CA97232-0014-01EN

Supplement for Embedded MegaRAID SATA User's Guide

This document is to supplement the description to the Embedded MegaRAID SATA User's Guide. Please also refer to the "Safety Precautions" and "Embedded MegaRAID SATA User's Guide" accompanied with "Array Controller Document & Tool CD" when this document is used.

"2.1 SATA Setup Utility" (page 24)

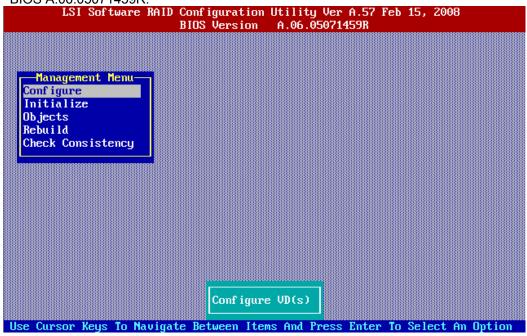
Version of expansion ROM BIOS is displayed as "BIOS Version" when using expansion ROM BIOS A.06.05071459R.

"4.4.4 Uninstallation of HDD Check Scheduler" (page 71)

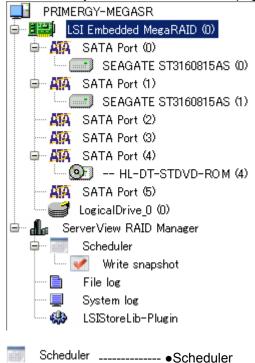
When in Windows Server 2008, operate in the same manner as Windows 2003. Refer to the Procedure of Windows Server 2003 for implementation.
